## PLANNING COMMISSION MEETING

## PLANNING COMMISSION STAFF REPORT

**PROJECT NUMBER:** 2013-31-DR- VA Clinic Design Review

**REQUEST:** Design Review application to construct a medical clinic for the Veterans Association

<b>SITE PLAN</b>	
DATE 06-19-2013	REVISION
PROJECT NUMBER 132075	SHEET NUMBER <b>A1.1</b>
SCALE

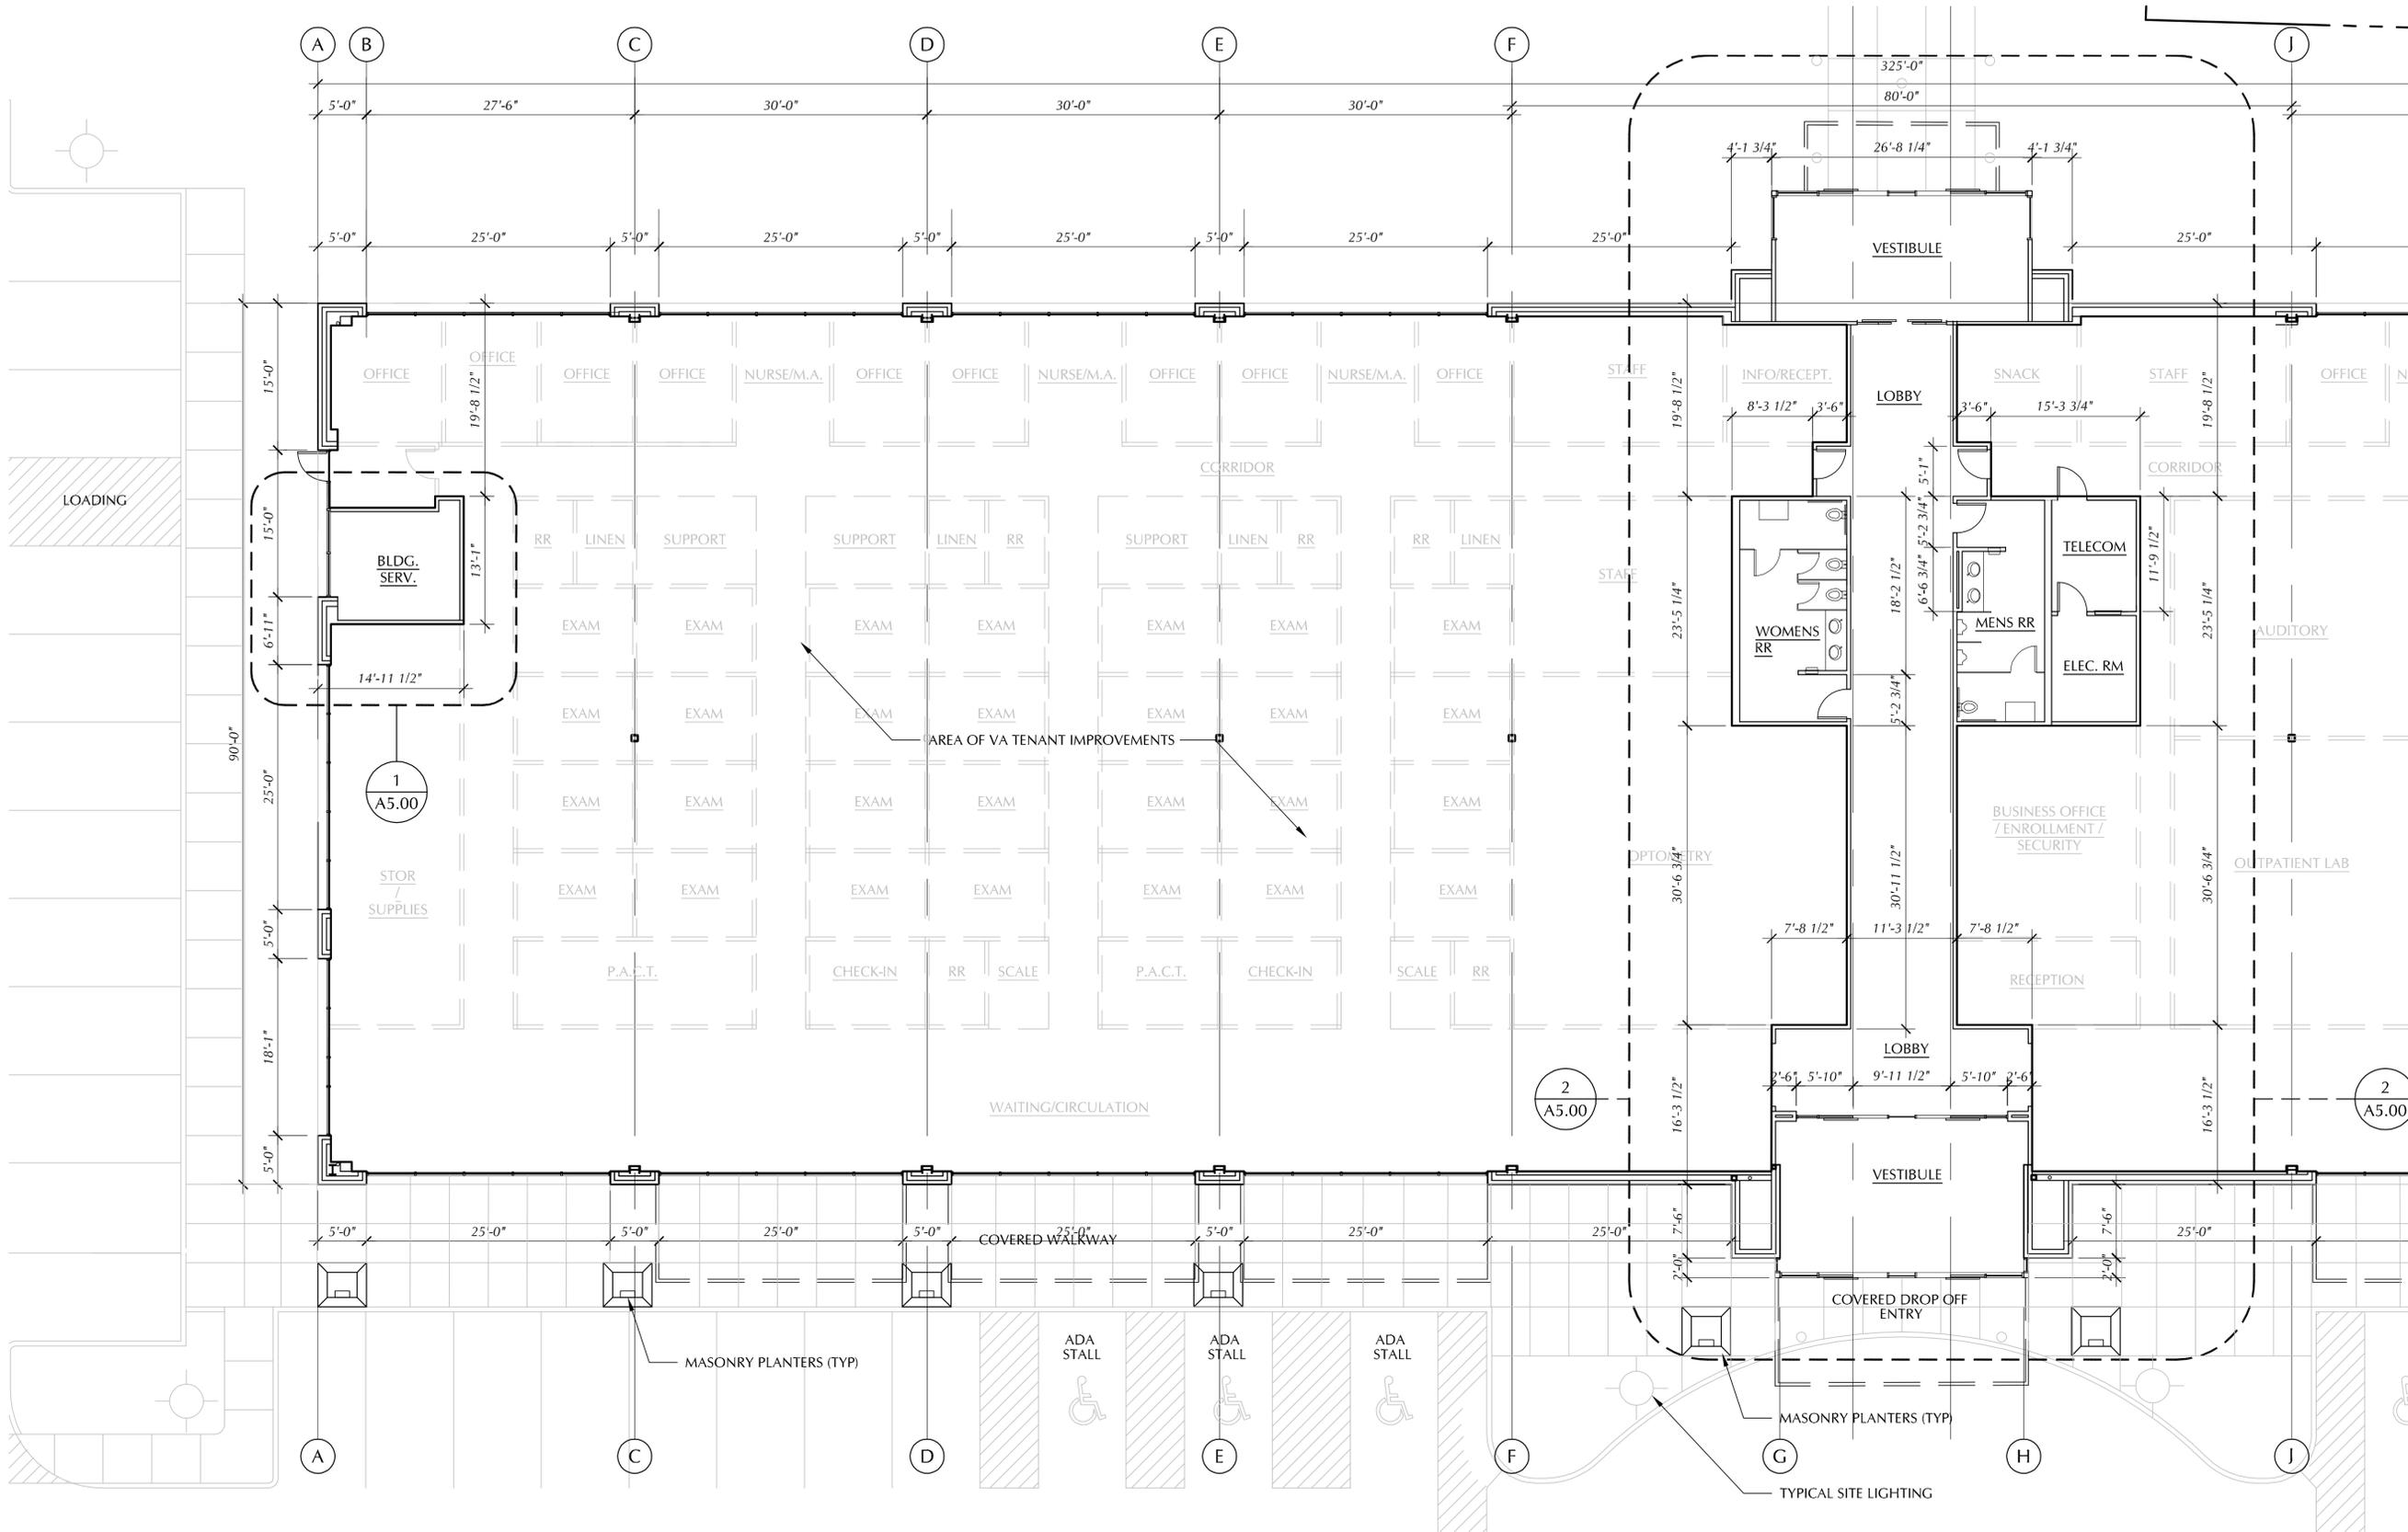
Staff Comment: The applicant proposes a medical clinic in the general office use category for purposes of determining parking requirements. The proposed plan includes 120 parking spaces, including 12 ADA stalls. There is also a large bus/van parking stall near the entry. Since there is an excess of parking stalls provided, carpool/vanpool parking stalls are not marked on the site plan. The proposal has an excess of 60 parking spaces.

Staff Comment: The site plan indicates bicycle parking will be provided near the main entry on the south side of the building, and in the northwest corner of the building parking lot area. To meet the standard at least three (3) bicycle parking spaces provided in accordance with the dimensional and locational requirements shall be required.

Staff Comment: There are no marked car/van pool parking spaces. There is a bus/van parking stall just west of the main south building entry. This criterion can be met with a condition that at least three (3) stalls shall be exclusively marked for car/van pool parking near the entry area.

Staff Comment: In the southwest corner of the parking lot a trash/recycle dumpster is located within a corner of the lot near the Market Drive access entry. The trash/recycle facility and adjoining area shall be landscaped to effectively screen it from public rights-of-way as a condition to meet this criterion.

DATE 03-05-2013	REVISION
PROJECT NUMBER 132075	SHEET NUMBER A3.0
SCALE

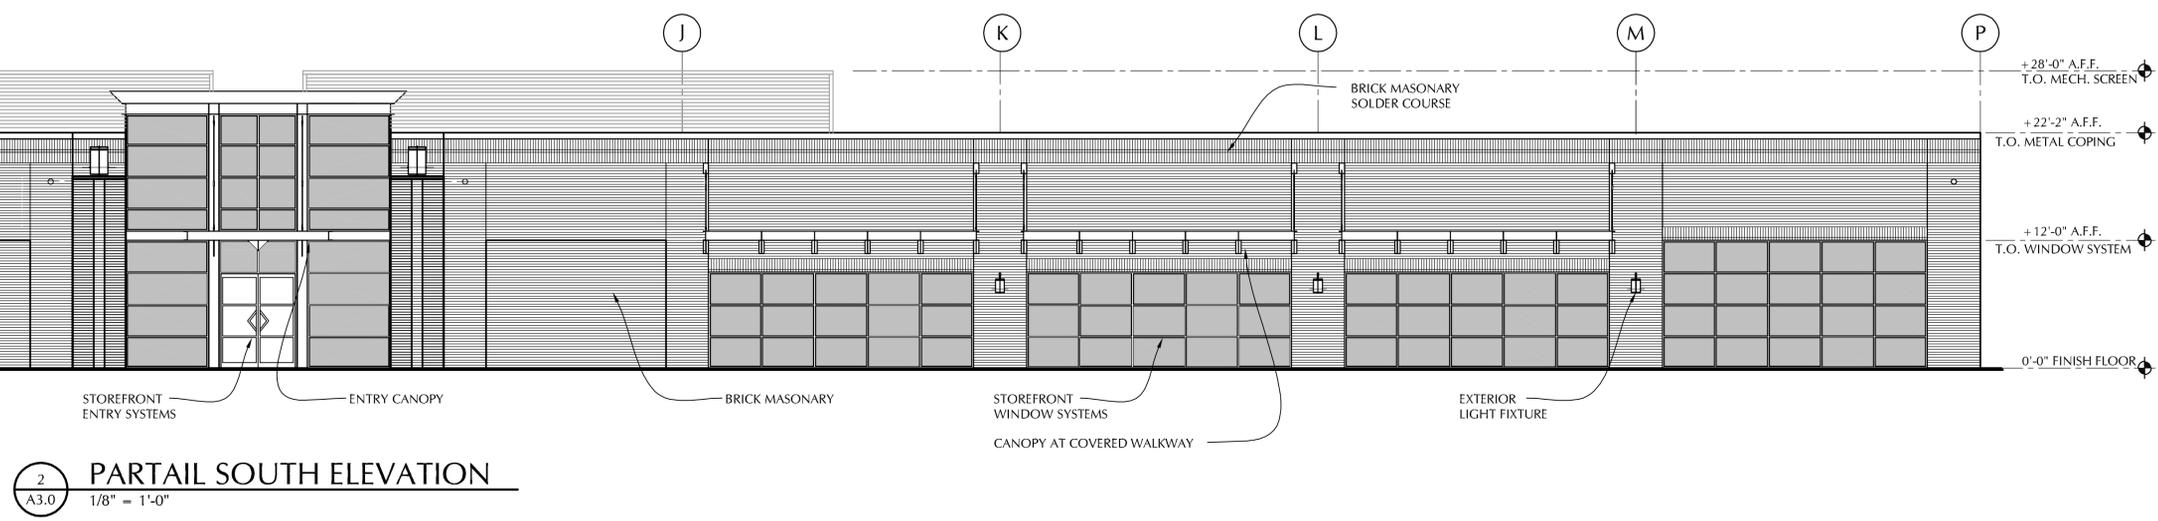
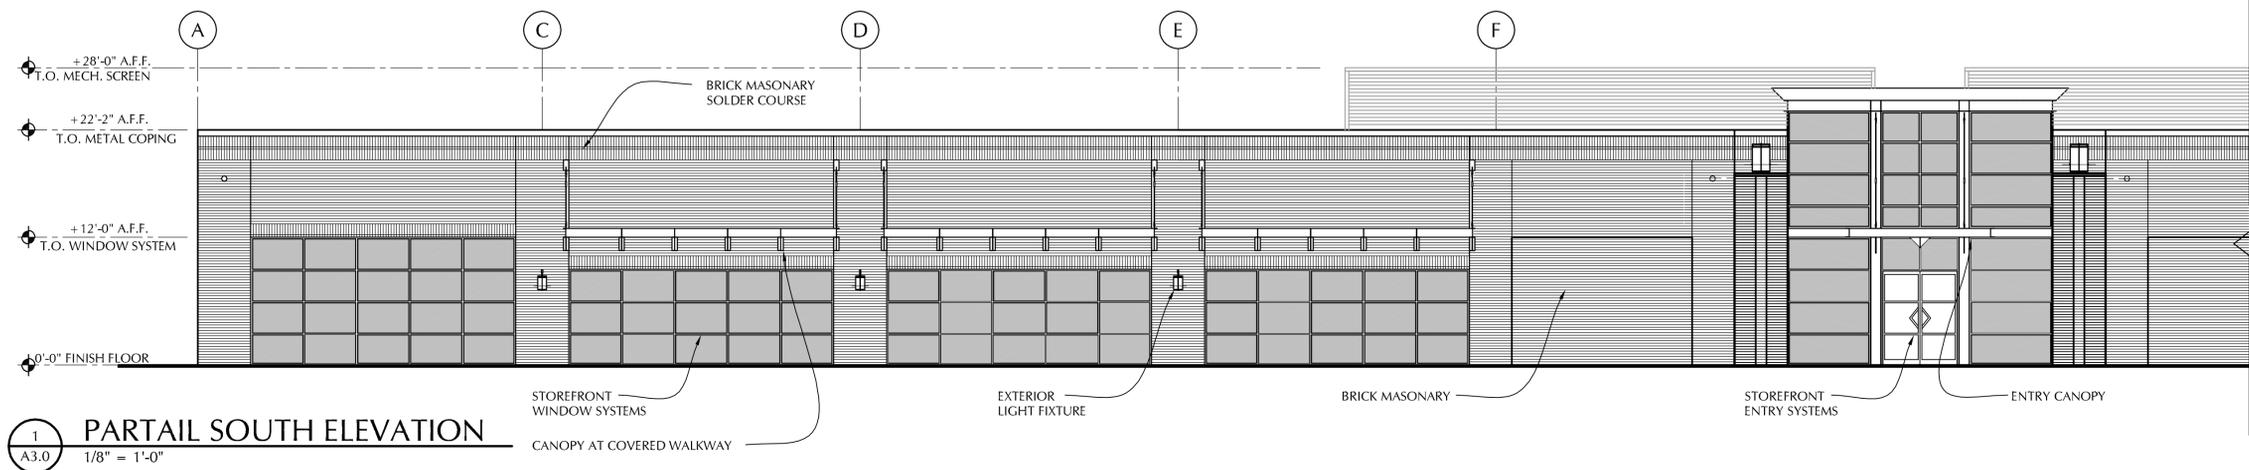
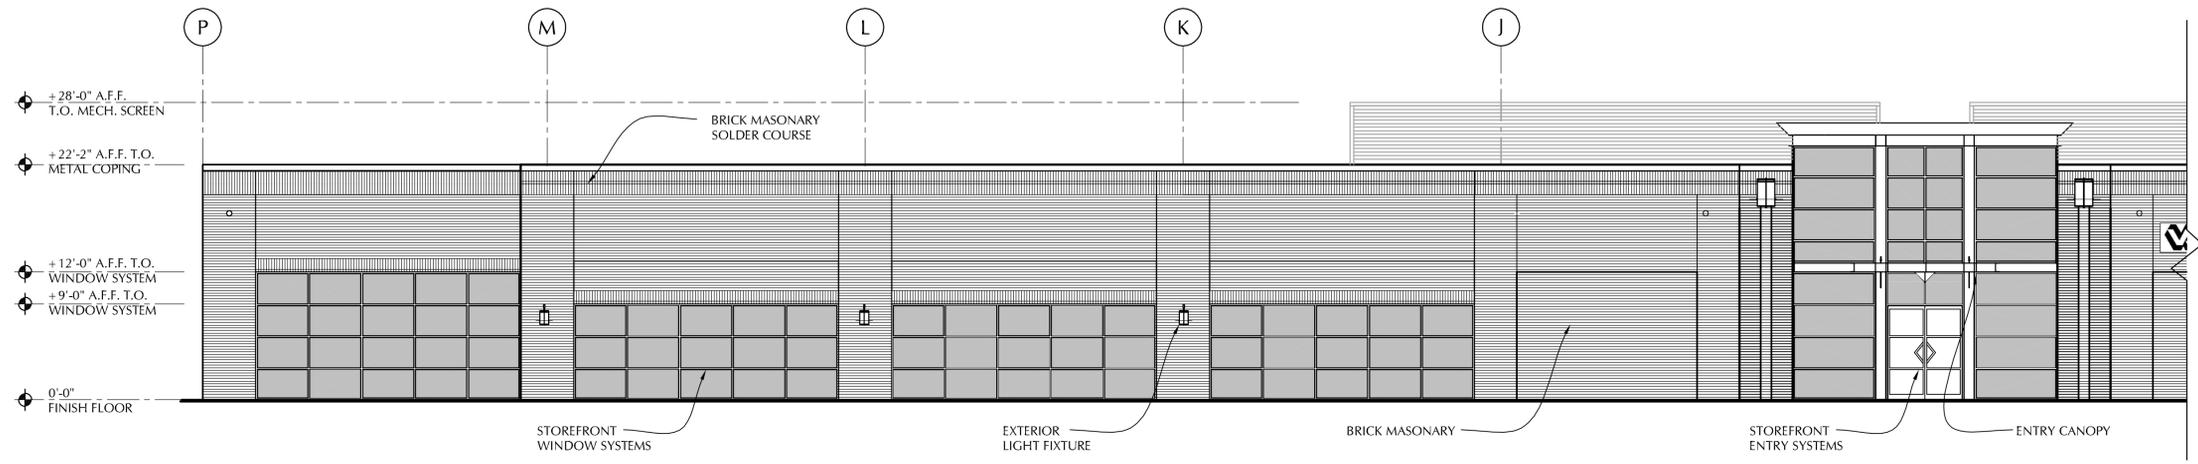
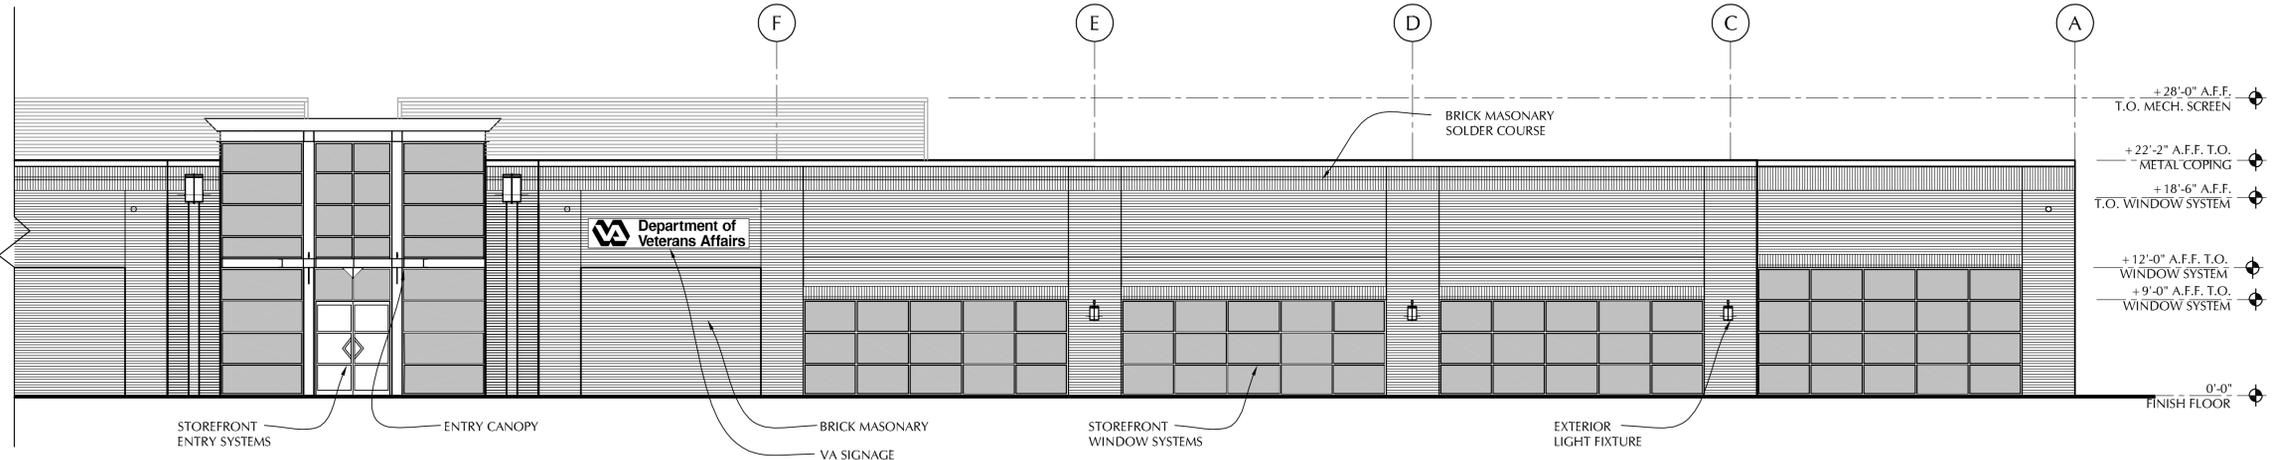
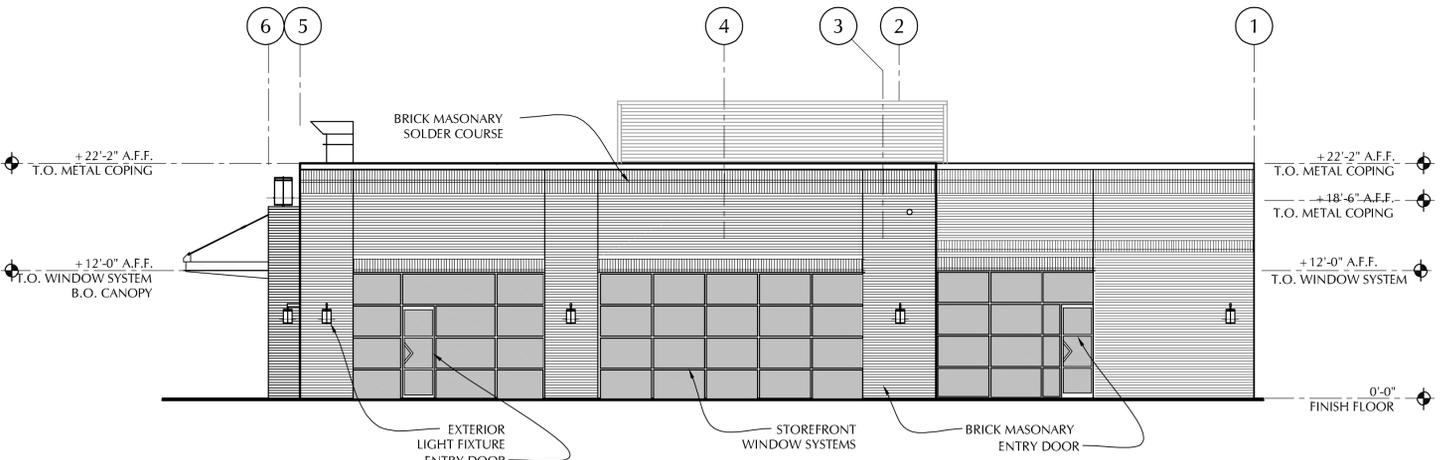
Staff Comment: Per the plan elevations, it appears that this standard is met through the use of brick masonry soldier course, storefront window systems, metal coping and metal canopy covered walkways and entries. The applicant has not supplied a color/material board for this review. The applicant indicates the building materials will mimic those of existing village buildings.
